Plot 23 and the Potential Knock-On Effect Along the Lingards Road Frontage

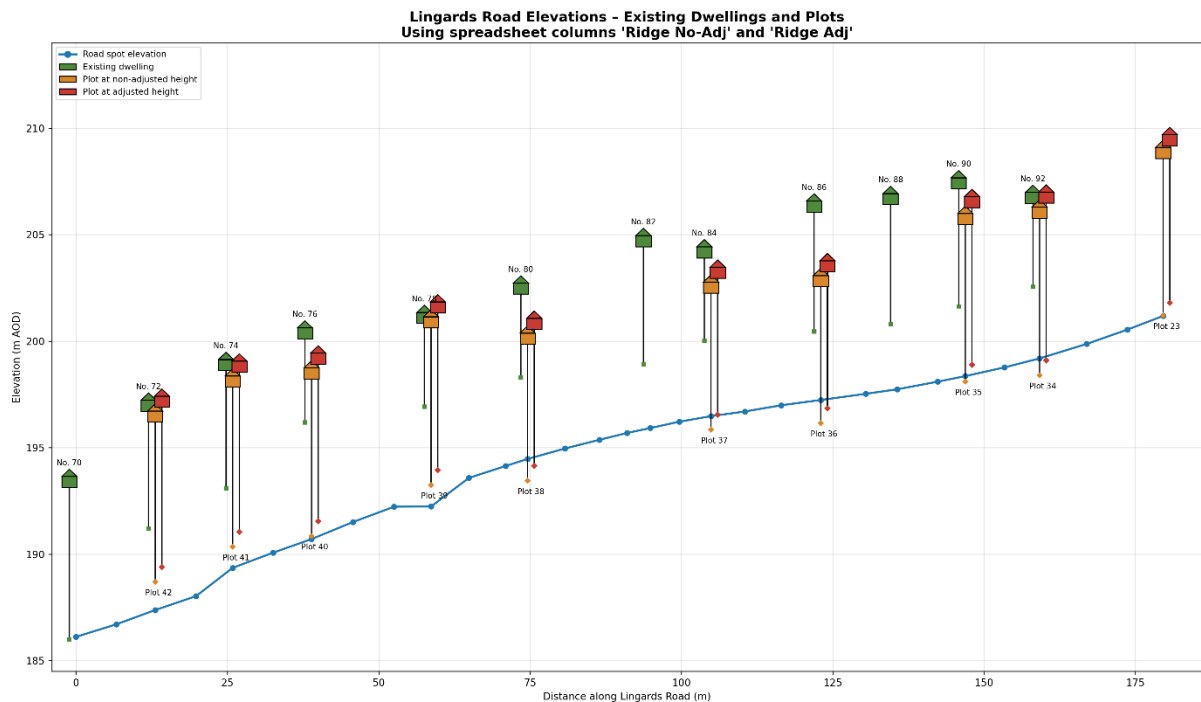
The graph above illustrates the relationship between the ridge heights of the established dwellings on Lingards Road and the approved ridge heights of the development opposite. Existing dwellings are shown in green, the non-adjusted/approved plot ridges in orange, and an indicative adjusted scenario in red.

This is relevant to 2026/91657 and Plot 23 because the Council has now established that Plot 23 has been constructed above its permitted level. Plots 34 and 35, which continue the same frontage, are also being investigated in respect of their levels. If these first three dwellings are not corrected so as to comply with their respective permissions, there is a legitimate concern about the physical level from which the remaining, as yet unbuilt, Lingards Road plots may subsequently be set out.

The graph illustrates what such a knock-on effect could mean in practice. It does not assert that the unbuilt plots are already too high, or that they will inevitably be constructed too high. For those plots, the red position is an indicative scenario applying an adjustment of approximately 0.697m, derived from the average elevation discrepancy presently indicated by Plots 23, 34 and 35.

What is noticeable is that the effect is not simply to move every new ridge upwards by a small amount. It changes some of the relationships which the approved scheme would otherwise have maintained between the new development and the established frontage opposite.

For example, on the approved figures Plot 42 has a ridge of approximately 197.06m AOD, below the 197.57m ridge of No.72. With the indicative adjustment, Plot 42 would rise to approximately 197.76m AOD, placing its ridge above No.72.

Similarly, Plot 39 has an approved ridge of approximately 201.49m AOD, below the 201.69m ridge of No.78. With the indicative adjustment it would rise to approximately 202.18m AOD, again reversing the intended relationship and placing the new dwelling above the ridge of the established property opposite.

This demonstrates why the treatment of Plot 23 cannot sensibly be viewed in isolation. Plot 23 is the first and most prominent part of this sequence of development along Lingards Road. If its excessive level is allowed to remain through 2026/91657, particularly if excessive levels at Plots 34 and 35 are also left uncorrected, those constructed dwellings risk establishing a different physical height relationship from the one authorised by the approved scheme.

The graph therefore does not illustrate an unavoidable consequence of the approved development. It illustrates a potential knock-on consequence if the excessive levels of the first constructed plots are allowed to remain and influence what follows.

Conversely, correcting Plot 23 to its permitted level, and correcting Plots 34 and 35 if their investigated levels are confirmed to be excessive, would restore the approved basis from which the remainder of the frontage can be constructed.
